**AGENDA
PLANNING COMMISSION
CITY OF WYOMING, MINNESOTA
SEPTEMBER 14, 2021
7:00 PM**

TO: Planning Commission
FROM: Tom Ramler-Olson, City Planner
Fred Weck
MEETING DATE: September 14, 2021
RE: Preliminary Plat Review
APPLICANT/OWNER: Beckmann Custom Homes, LLC
PROPERTY: PID R21.00040.01, R21.00040.02, R21.00040.03,
R21.00040.04, R21.00040.05, R21.00040.06
FILE NO.: D-21-010

PRELIMINARY PLAT RE-PLAT OF DIAMOND RIDGE

DIAMOND RIDGE REPLAT - 261st STREET CUL-DE-SAC
BECKMANN CUSTOM HOMES
WYOMING, MN
DETAILS

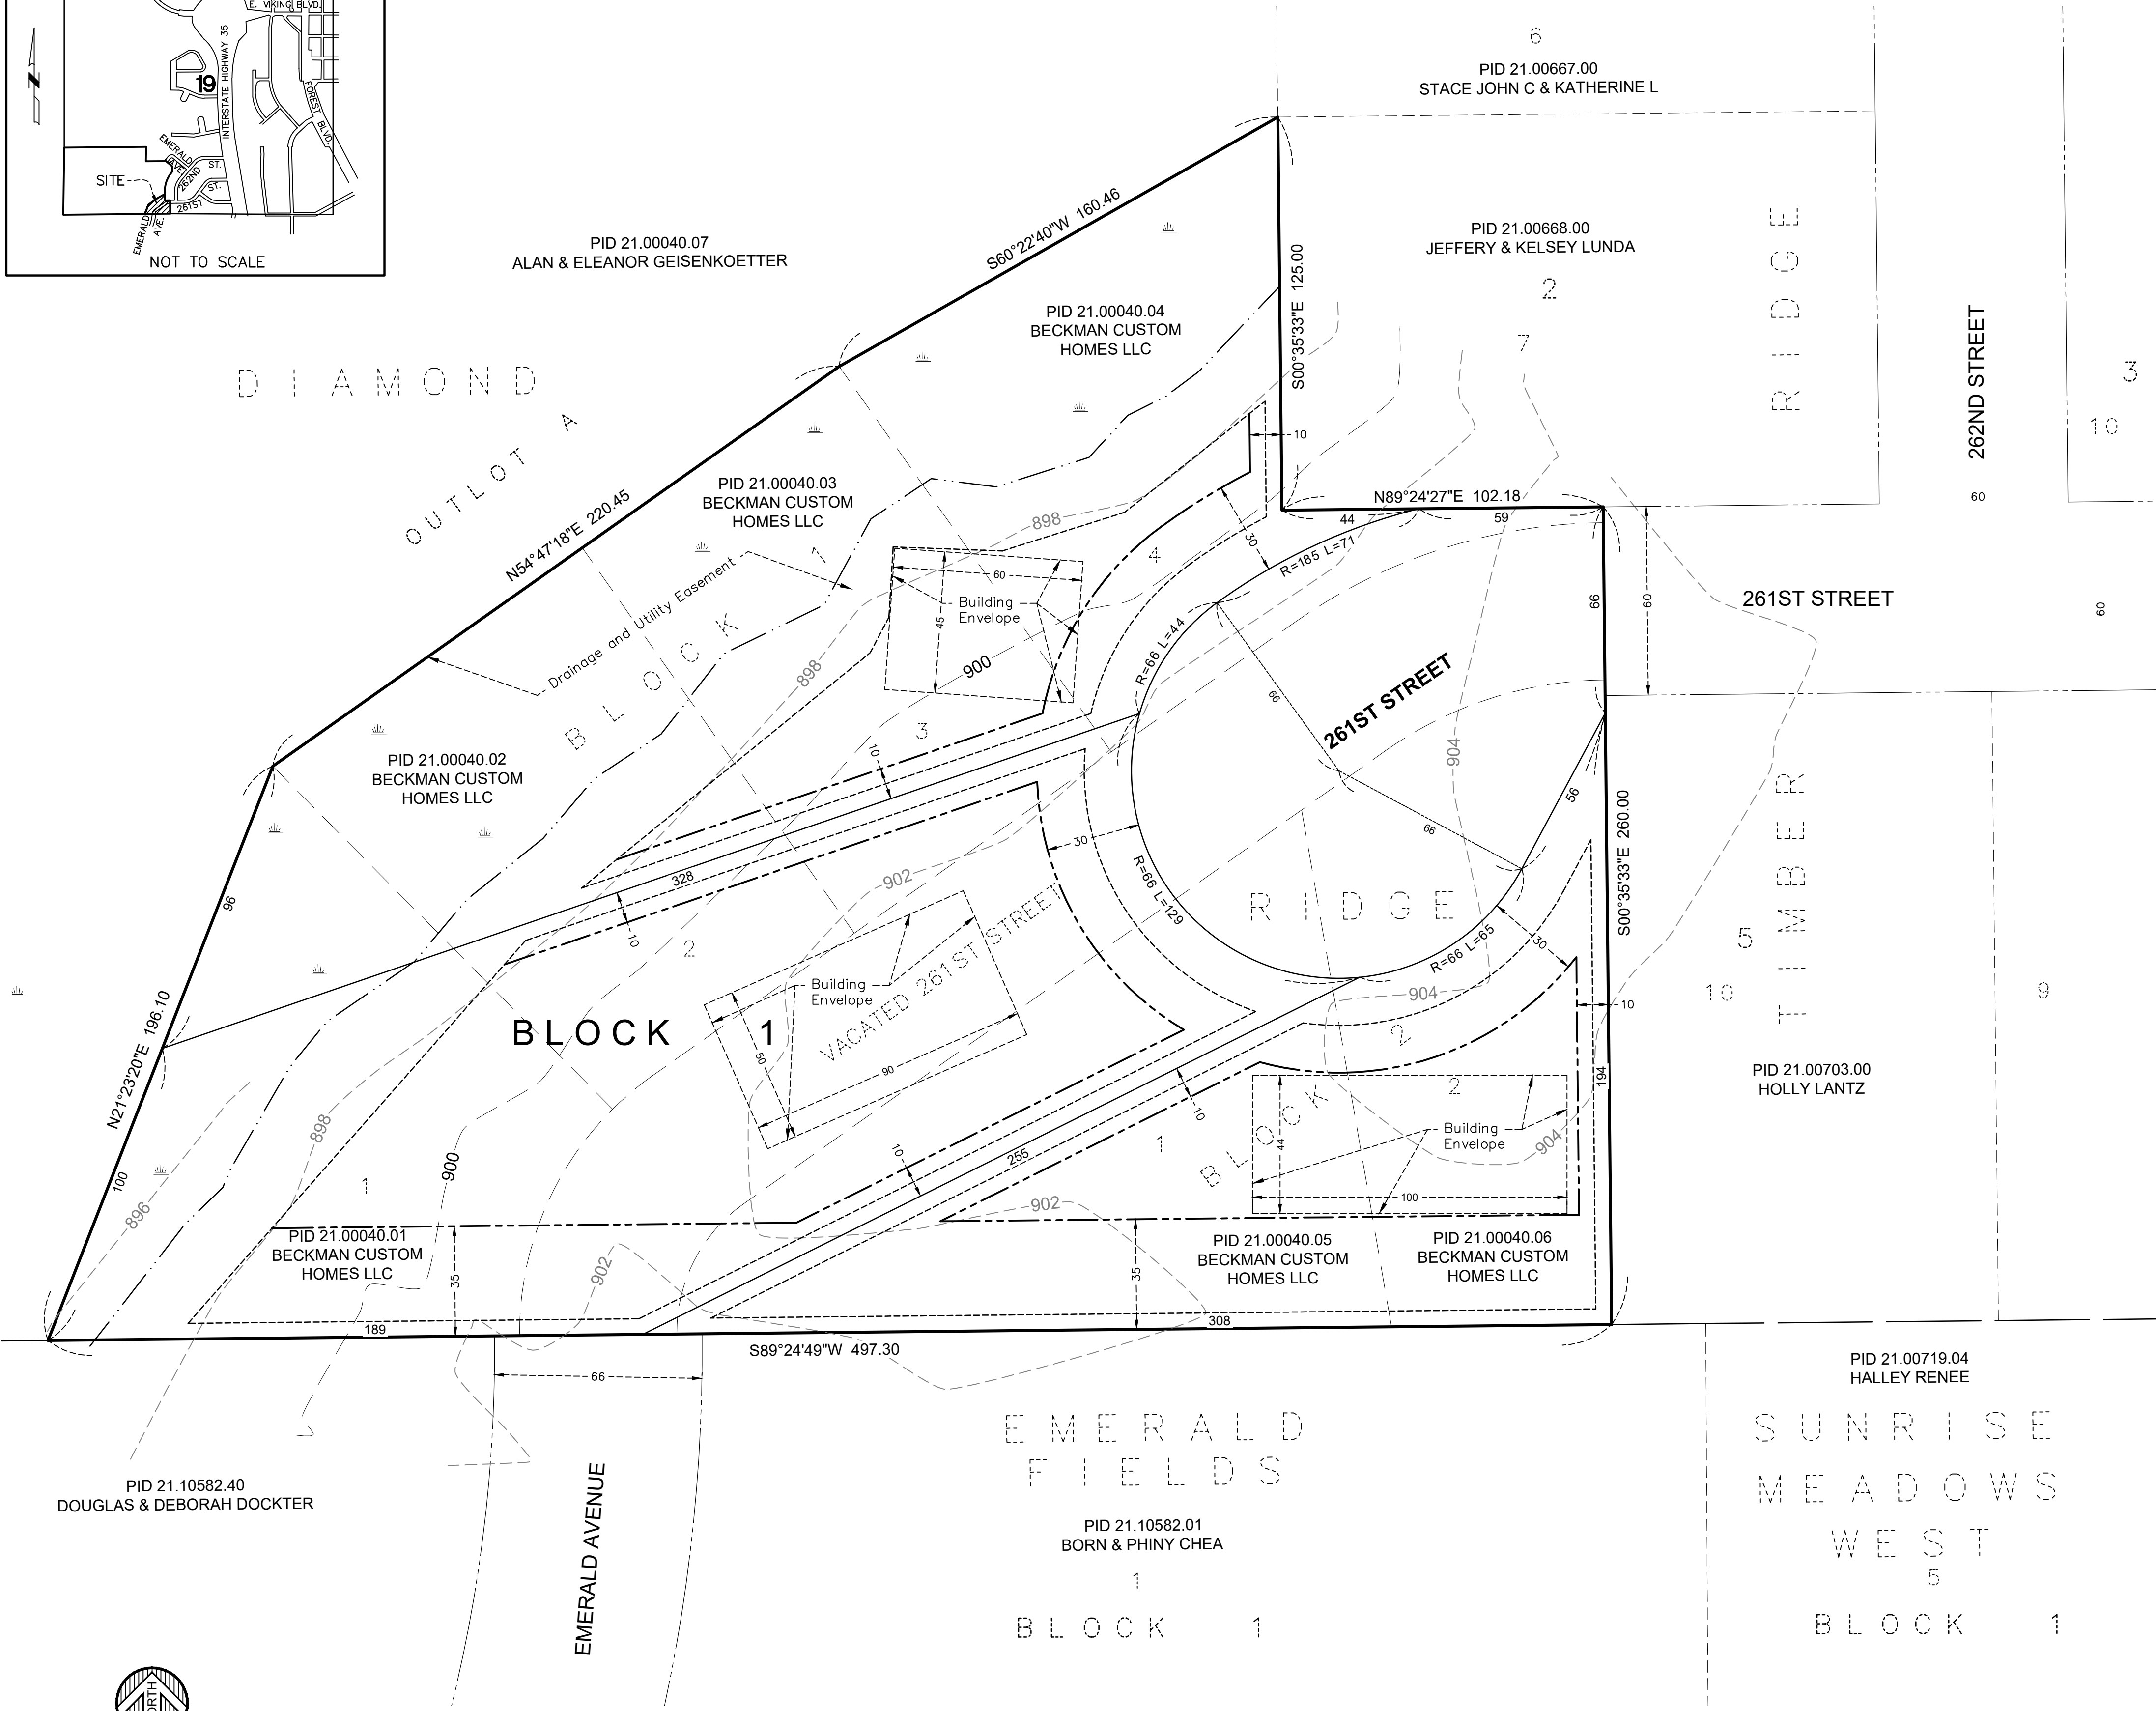
Lots 1 and 2 have lot areas of 42,800 square feet and 42,322 square feet, respectively; Lot 3 is at about 23,673 square feet. The area of Lot 1 is diminished by the wetland, which consumes about 25,000 square feet, leaving about 18,000 square feet. The area of Lot 2 is also reduced by 3,700 square feet, which is still leaves about 40,000 square feet. Lots 2 and 3 greatly exceed the maximum lot area for the land use category of the project area. However, they will be served by municipal sewer and water.

The proposed lots meet all R-3 dimensional standards.

The preliminary plat shows 261st Street terminating within the project area as cul-de-sac bulb. Staff is comfortable with the proposed cul-de-sac rather than the road making the through connection. 261st Street is an urban section and they are proposing a rural section for the cul-de-sac which is not a common practice. The applicant is choosing to move forward with the rural section cul-de-sac to likely meet their stormwater requirements given the lack of room for traditional stormwater management practices with an urban section roadway. Staff would like the applicant to evaluate installing an urban section consistent with the roadways leading into the development.

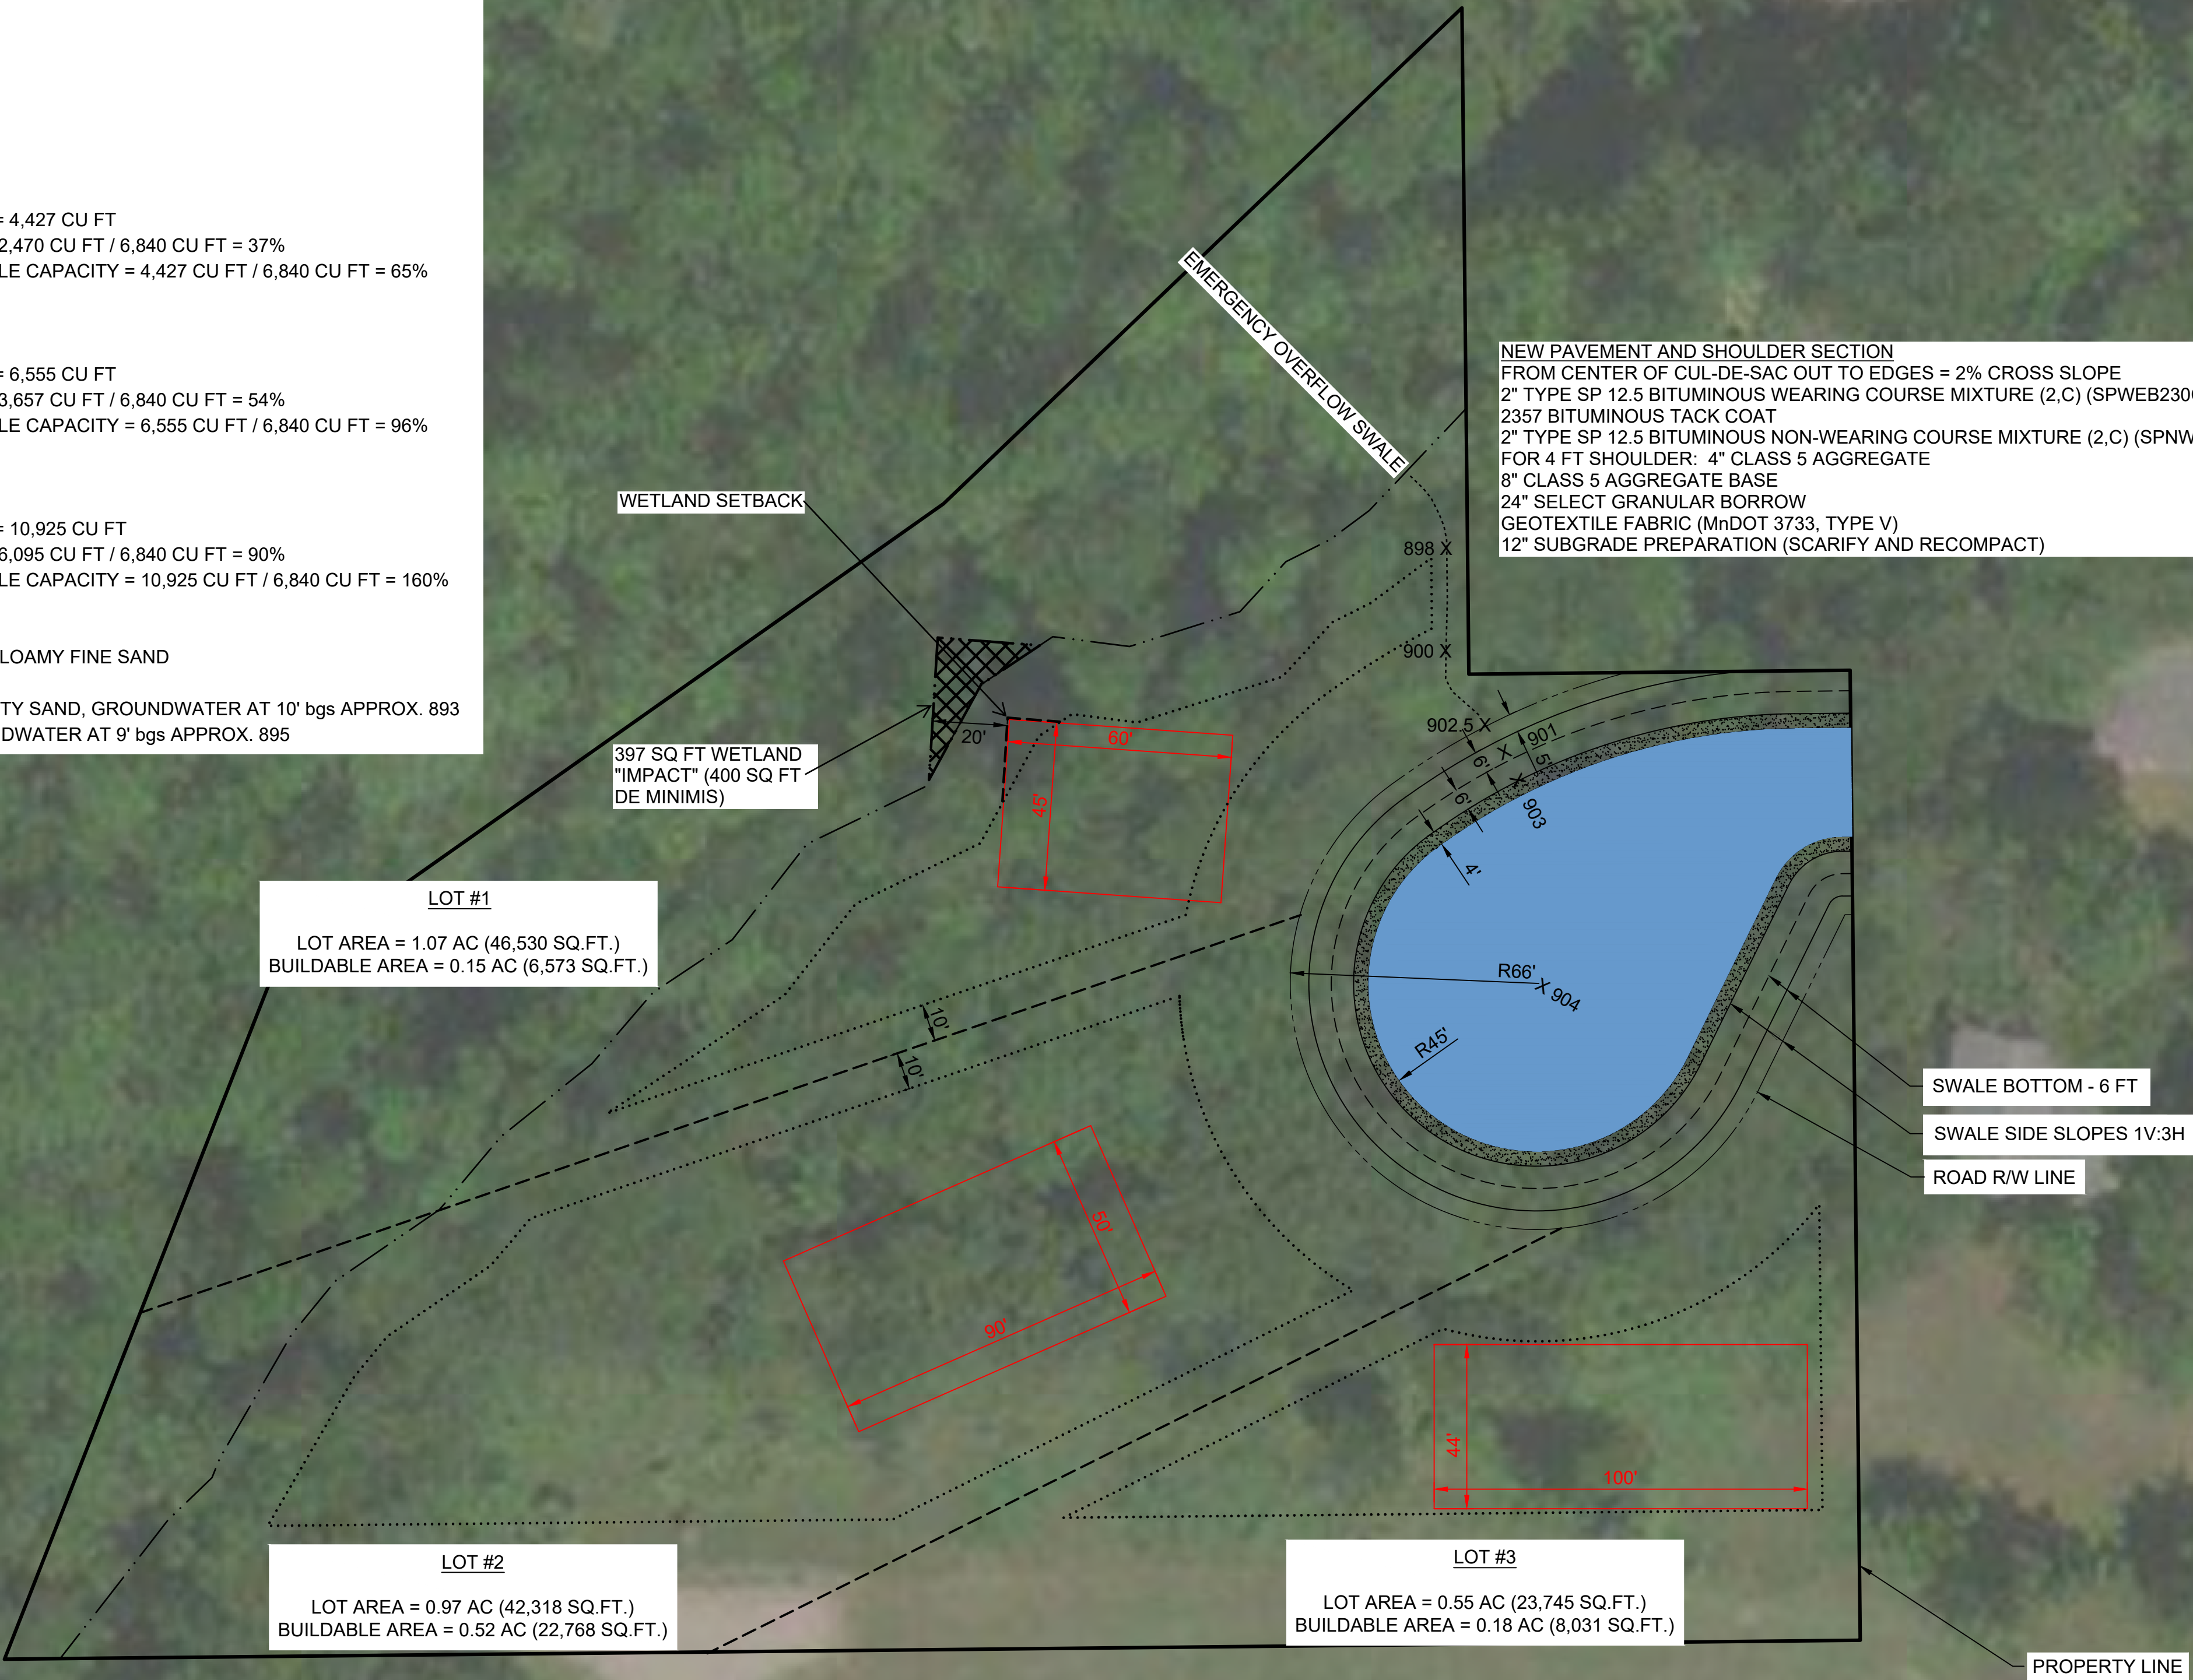
The applicant has not included a grading plan, but rather linework of the swale bottom and side slopes that follow the perimeter of the pond. It appears the swale will carry around the cul-de-sac and discharge into the wetland at the northern portion of the cul-de-sac. If the swale was at 1% grade the swale would be deeper at the outlet side by greater than 2-foot and the linework shown would not be reflective of what the grading would actually look like. The grading plan should also show the outlet swale adjacent to the neighboring property to ensure there are not impacts to this adjacent property.

Building type (slab on grade, look out, walk out, full basement) should be identified on the grading plan along with appropriate elevations to ensure adequate freeboard is provided from the 100-year high water level of adjacent wetlands.

DIAMOND RIDGE REPLAT - 261st STREET CUL-DE-SAC
BECKMANN CUSTOM HOMES
WYOMING, MN
UTILITY PLAN & PROFILE

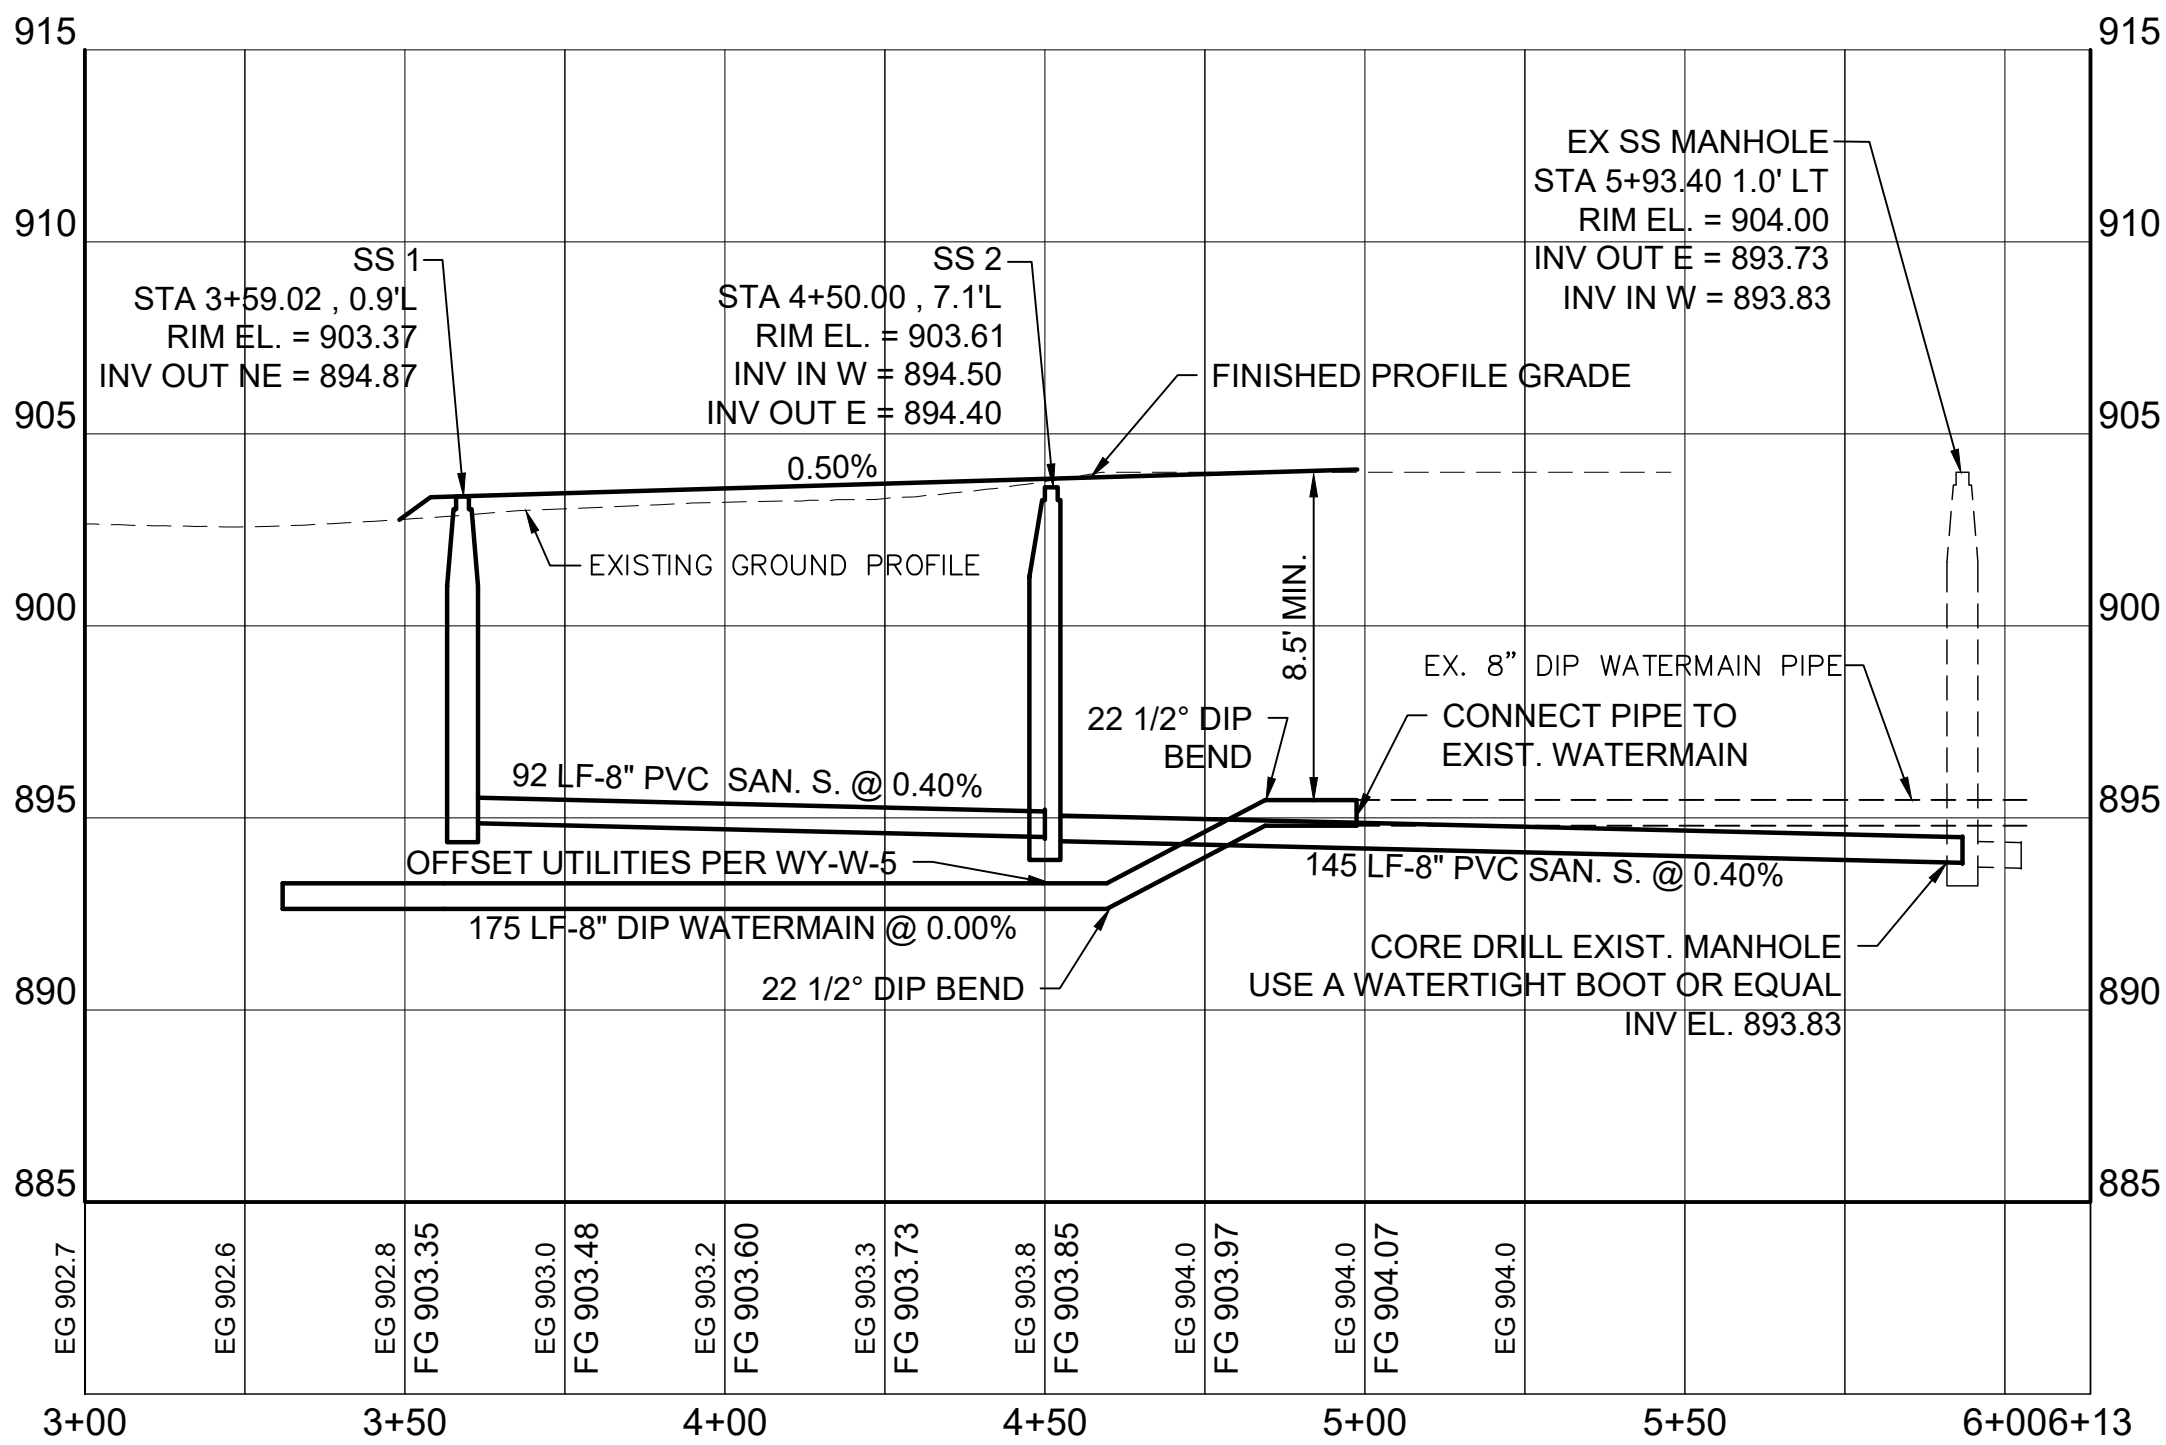
There is existing watermain and sanitary sewer available within 261st Street to serve the proposed lots. The development is proposing extending the 8-inch watermain and 8-inch sanitary sewer into the cul-de-sac to serve the three proposed lots. A portion of 261st Street will require removal of asphalt pavement with the curb likely be saved. The roadway will require curb to curb pavement section replacement where disturbed by proposed utility construction. This was reflected on previous plans; however it is not shown on the current plan.
